Planning Commission

Planning Commission Meeting Agenda
Hartland Township Hall
Thursday, June 27, 2024
7:00 PM

Hartland Township Planning Commission Meeting Agenda Memorandum

Subject: Site Plan PD Application #24-003 Redwood Living Planned Development (PD) Phase II – Preliminary PD Site Plan (**Revised Plans dated June 6, 2024**)

REDWOOD HARTLAND PHASE 2 - SHARED MONUMENT SIGN EXHIBIT

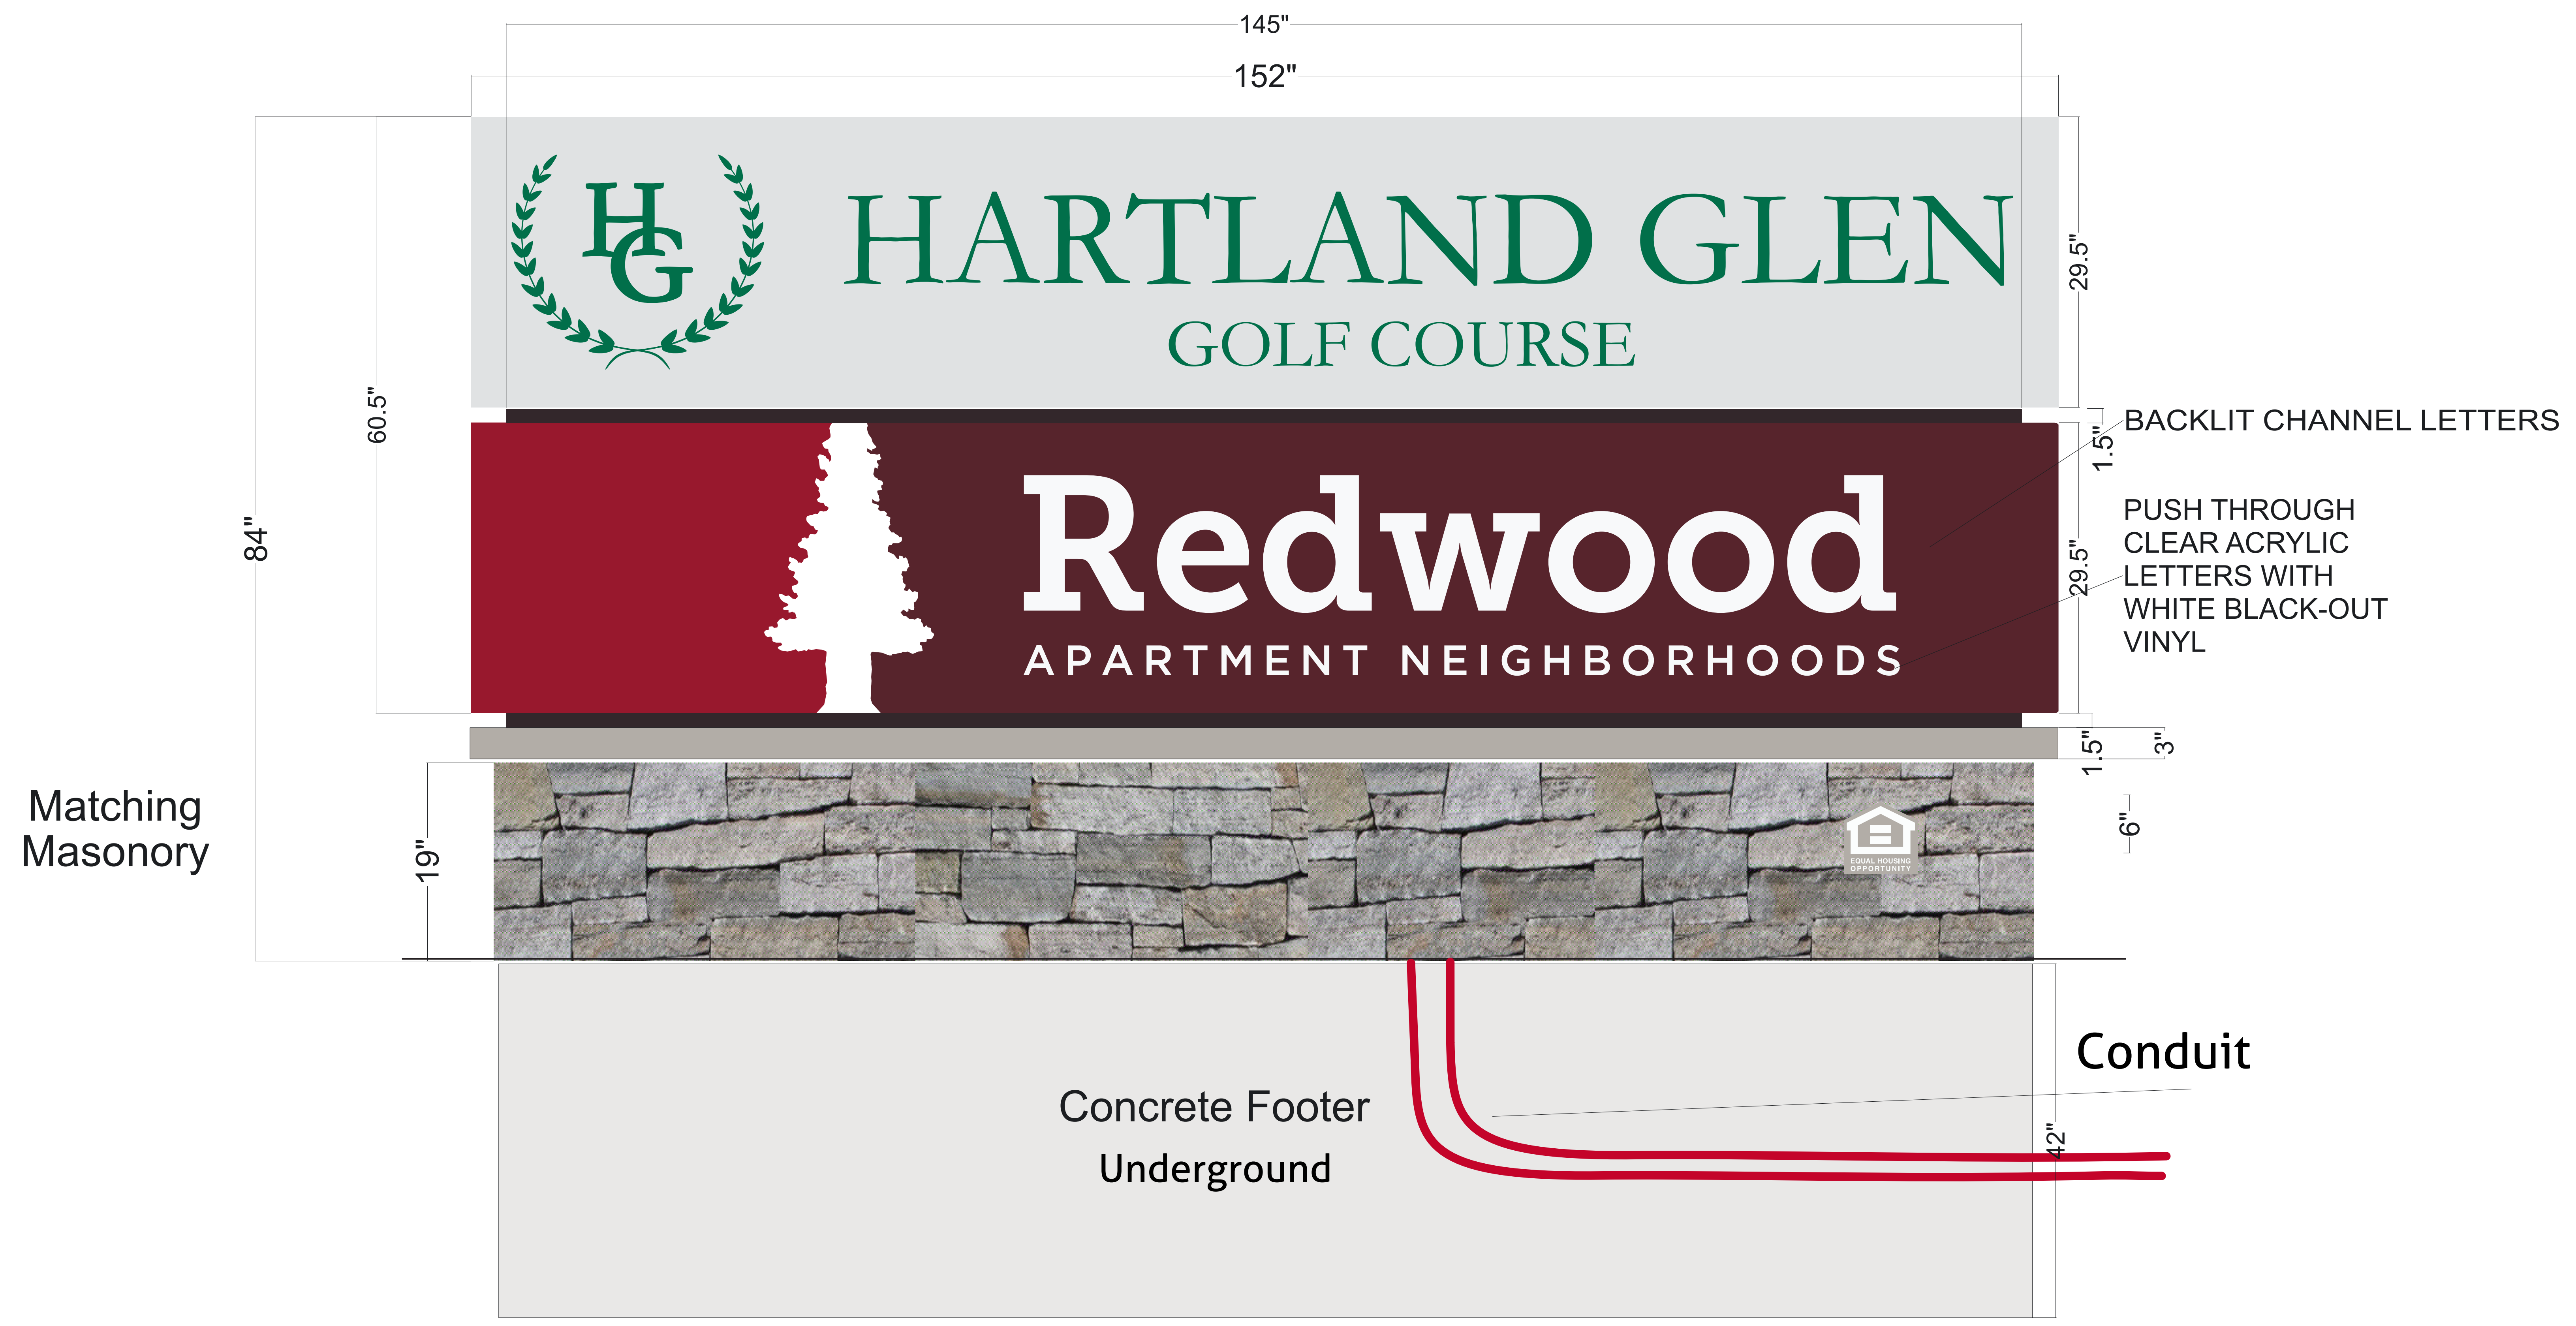
The revised monument sign drawing shows two (2) sign panels, with one sign panel for Hartland Glen Golf Course and one for Redwood Apartment Neighborhoods. Additionally, a second off-site interim/construction sign is proposed on the same parcel. A drawing of the sign is provided. The applicant has requested a waiver for each off-site sign as part of this request. Additional information is provided in a separate section of this memorandum.

SHEET TITLE: **OVERALL SITE PLAN**
 SHEET NUMBER: **C200**

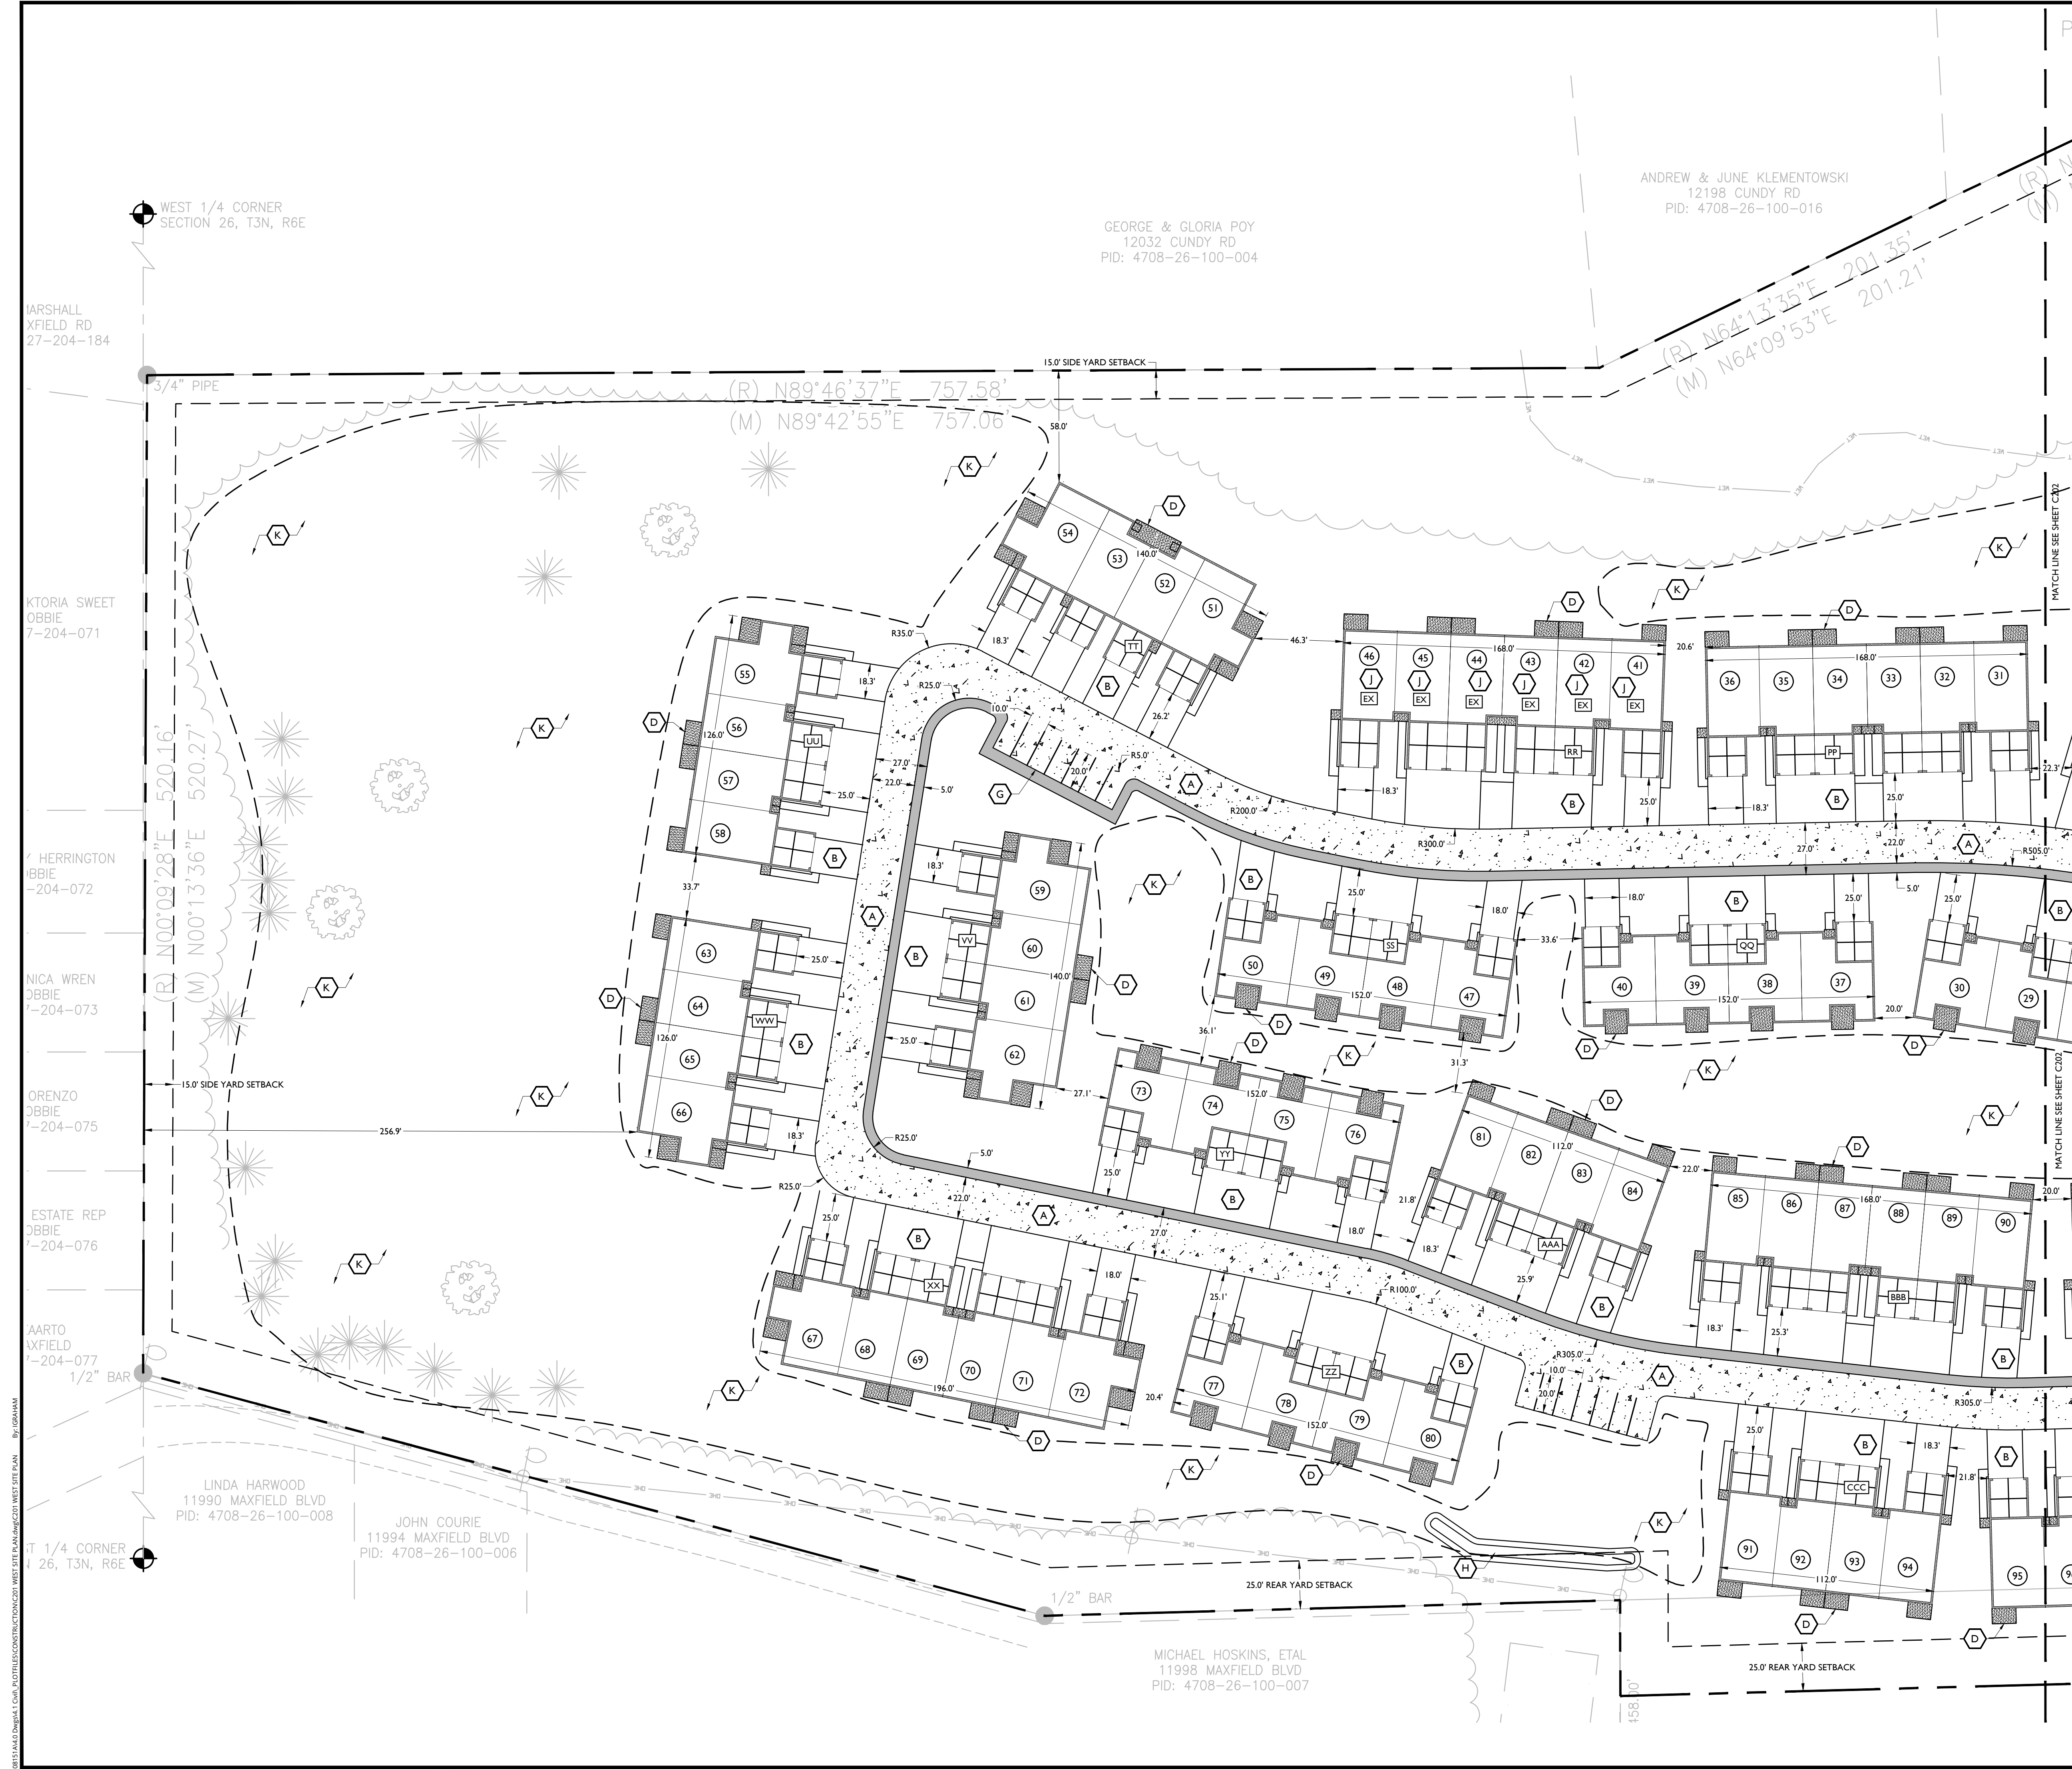
1. Provide a copy of Lot Split. Include Parcel ID with description on drawing X100.
2. Drawing C200: Offset distances listed in zoning information on Drawing X100 and in PD regulation table 3.1.18.C.vi.a of the township ordinances are not met. Approval from the planning department will be required for design variance.
3. Drawing L2.0: Landscaping shall not be proposed within utility easements unless approved by Hartland Township.

Sheet C200 lists the proposed yard setbacks as follows: front (15) feet, side (15 feet), and rear (15). Sheet C201 shows the south property as a 15-foot side yard. Sheet C202 shows a 15-foot front yard. In order to be consistent with the yard setbacks for Redwood Living Phase I, the setbacks for Phase II should be as follows: front yard setback should be eliminated; rear yard setback of 25 feet should be along the south property line; and side yard setback of 15 feet should be along all other boundaries of the property. The revisions should be shown on the Construction Plan Set.
